JRPP No:	2010SYE104
DA No:	DA2010/1979
Address / Property Description:	Part Lot 11 DP 577062, No. 23 Fisher Road, Dee Why Stage 1 concept mixed use development comprising residential and commercial uses and basement car parking
APPLICANT:	The Salvation Army NSW Property Trust – C/- Hassell
REPORT BY:	Malcolm Ryan, Director Strategic and Development Services

Assessment Report and Recommendation

Figure 2 Building identification
(Source: Plan No. SK-120 dated 11/10/2010 prepared by Hassell)

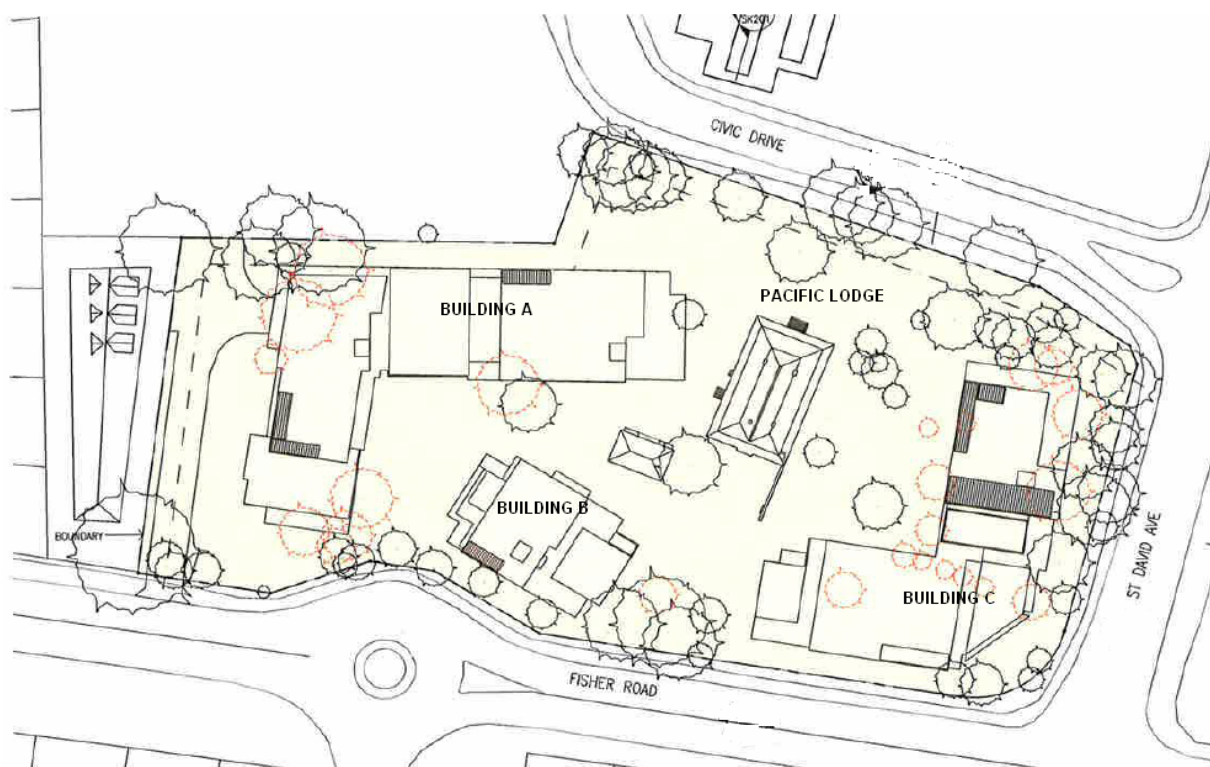
The landscape plan submitted with the application (see Plan No. SK-120 dated 11/10/2010) does not provide sufficient detail to enable an accurate assessment of the impact of the development upon existing vegetation or provide any indication of possible future planting throughout the site to ascertain how the landscaping and buildings operate as an integrated and sustainable system.

Council’s Landscape Officer notes (refer to ‘Internal Referrals’ in this report) that the Landscape Plan shows trees to be retained and removed but questions the accuracy of the plan given that the placement of the building footprints (in particular, Building A which is sited close to the pocket of bushland to the north-east) will impact upon the root systems and canopies of significant trees and prominent stands of trees (ie *Angophora costata* (Sydney Red Gum) along St. David Avenue). Additionally, Council’s GIS system notes that the site may also contain stands of *Corymbia gummifera* (Red Bloodwood) and *Eucalyptus macrocarpa* (Eucalytus) which may provide habitat for threatened flora or fauna species and thus have higher conservation significance. Council’s Landscape Officer therefore considers it to be important for an application on this property to include a comprehensive Flora and Fauna Assessment and an Arboricultural Impact Assessment. However, the conditioning of a Stage 1 DA consent to require the submission of a Flora and Fauna Assessment and an Arboricultural Impact Assessment with a Stage 2 DA it is not considered to be appropriate as the Plan may require the repositioning of the building footprints to which this application seeks approval.

Figure 3 Built form surrounding the site

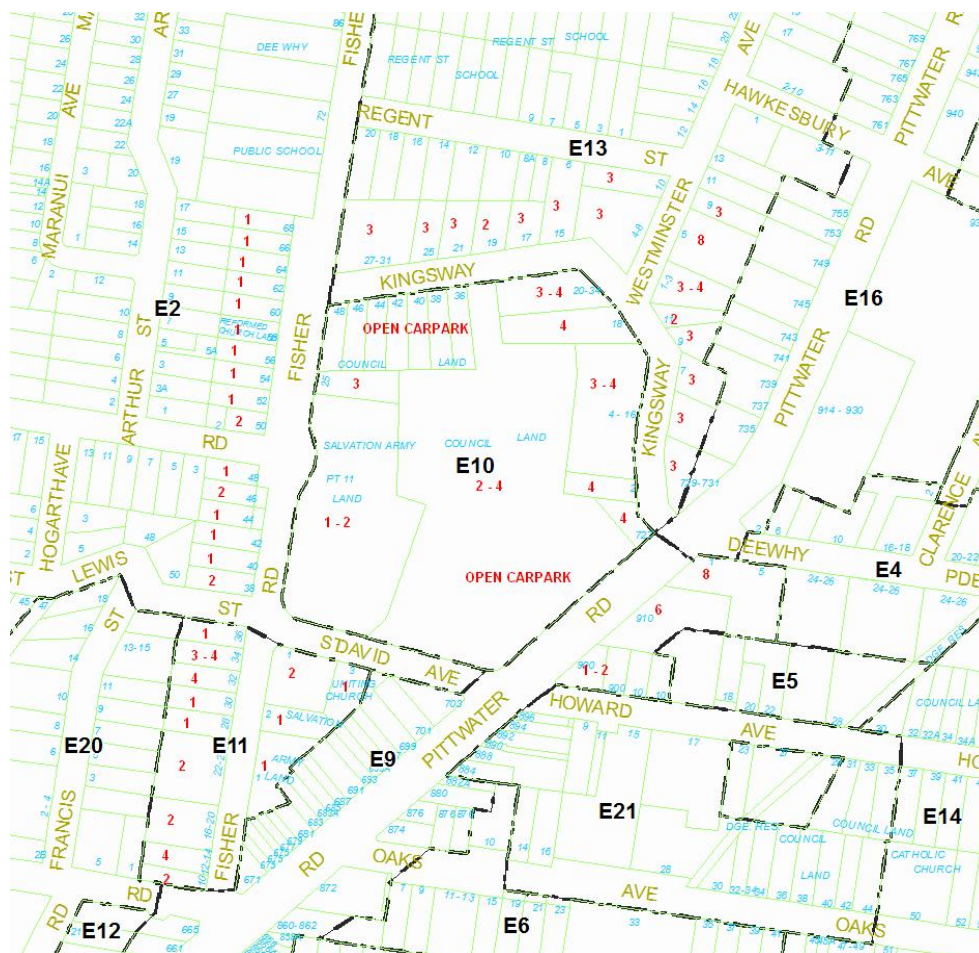
As can be seen in the illustration above, the scale of existing development along Fisher Road (within the E2 Dee Why Lagoon Suburbs Locality) predominantly consists of single and double storey dwellings with the recently constructed 3 storey residential flat building at No. 25 Fisher Road being the only exception.

Figure 4 View from Fisher Road
(adapted by the author from Plan No. SK-150 dated 11/10/2010 and prepared by Hassell)

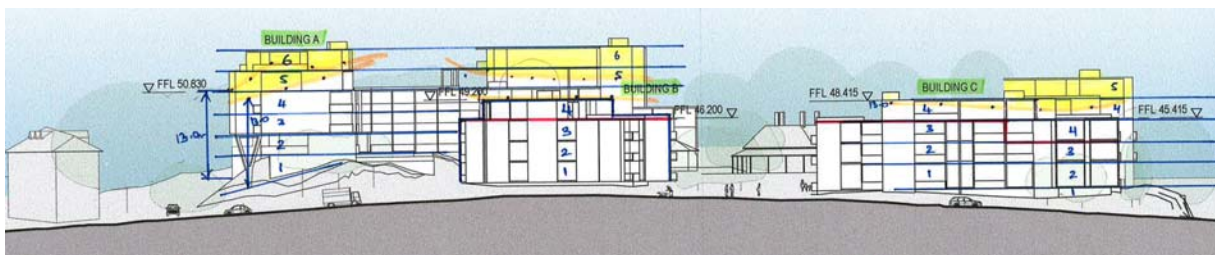
- Shaded yellow areas indicate the extent of non-compliance with the 13.0m building height.
- Solid red lines indicate the permitted 3 storey building height limit relative to natural ground level.

The non-compliance occurs on the Ground Floor of Building C (see Figure 4 above).

Figure 5 View from Civic Drive
(adapted by the author from Plan No. SK-151 dated 11/10/2010 and prepared by Hassell)

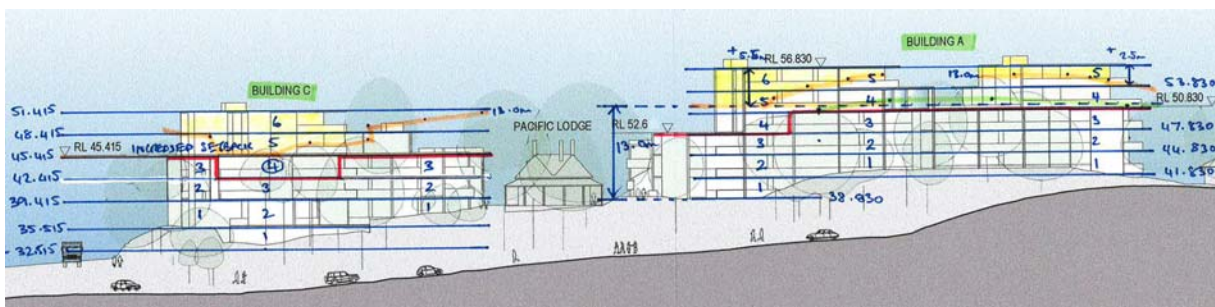
Figures 5 and 6 above show that the eastern side of the development is stepped up from the western side of the development to maximise the availability of views towards to ocean. The result, as indicated by the non-compliant building envelope along the eastern side of Building A, is a visual exacerbation of the built form at the highest part of the site.
